Bituminous Interim Inspection

PROJECT NUMBER	B190846/1	AREA MANAGER	John Wilkinson
PROJECT NAME	Paterson Building - Christie Hospital		
PROJECT ADDRESS	Christie Hospital, Wilmslow Road, MANCHESTER Lancashire M20 4DJ		
APPROVED CONTRACTOR	Primeseal Roofing Ltd		
TEL	0161 620 7557		
SITE CONTACT FOR ABOVE	Stephen Duffy (0161 620 7557)

Photo 11 - View of perimeter plinths to be completed

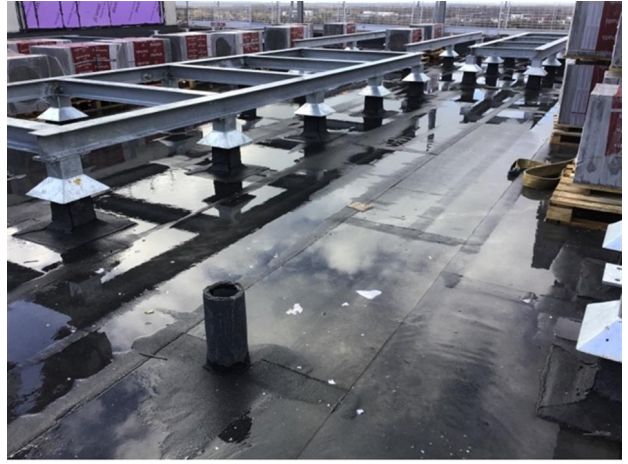
Progress to date as follows, ROOF 9 SECTION 1 is 95% complete with perimeter detail and plinth details to finish. SECTION 2 is 10% AVCL installed. SECTION 3 is approximately 70% AVCL installed

Photo 15 - View of section 1 that is passed for landscaping

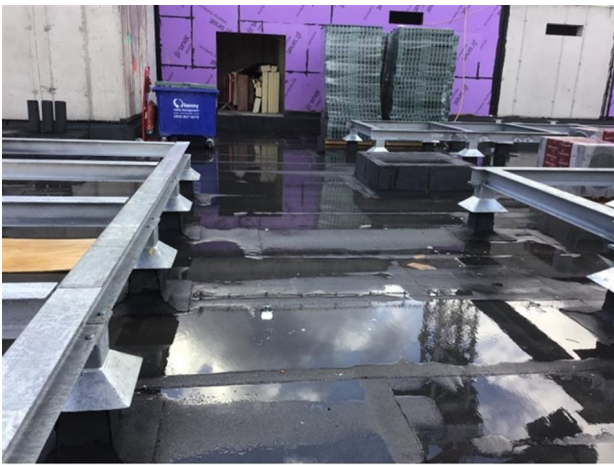
SECTION 1 is passed for landscaping
